# Goldy Precision Stampings

<b>Process</b>	520CJ00102- Dowel pin height modification.	<b>Supplier</b>	M/s Godly Precision stampings Pvt. Ltd.
		<b>Improved date</b>	22.04.2022

<b>BEFORE</b>	<b>AFTER</b>
---------------	--------------

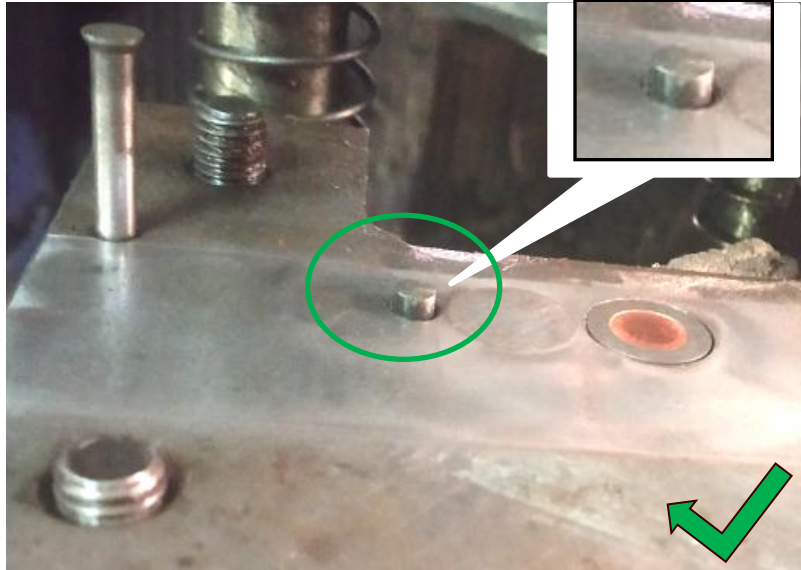
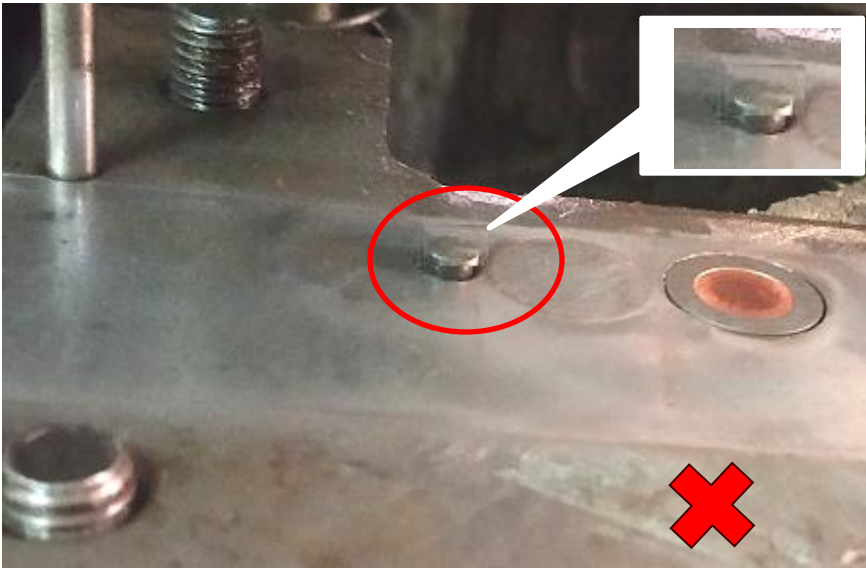
<b>Problem</b>	Blanking Tool- Dowel pin not ok, dowel pin height in sufficient	<b>Improvement</b>	Blanking Tool- Dowel pin height increase more than 2 mm of thickness. (Height increase 3.5 against 1.5mm)
----------------	-----------------------------------------------------------------	--------------------	-----------------------------------------------------------------------------------------------------------
